RE: Clarification of CS-PF panels for Lot # 101 Hawthorne Ridge – 3101 SW Arbortree Dr. Lee's Summit, MO 64082 – Permit # PRRES20212956

FIGURE R602.10.6.4 METHOD CS-PF—CONTINUOUSLY SHEATHED PORTAL FRAME PANEL CONSTRUCTION

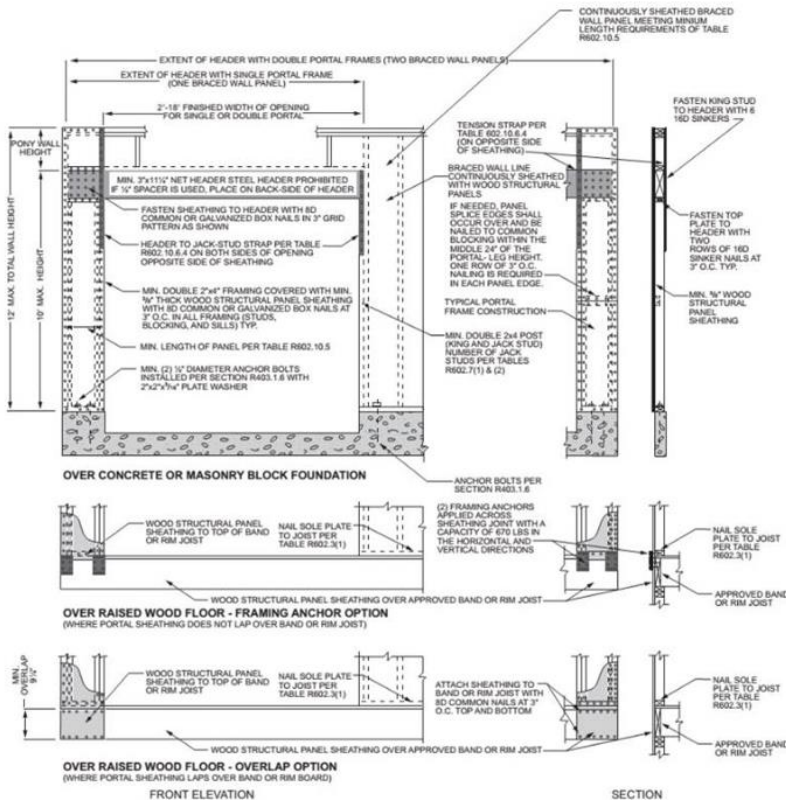
- CS-PF panels at flex room shall be installed on interior side of front flex room wall.
- Install CS-PF per R602.10.
- Attach to bottom plate with structural screws at 3" oc.
- Attach bottom plate to floor joists with structural screws.
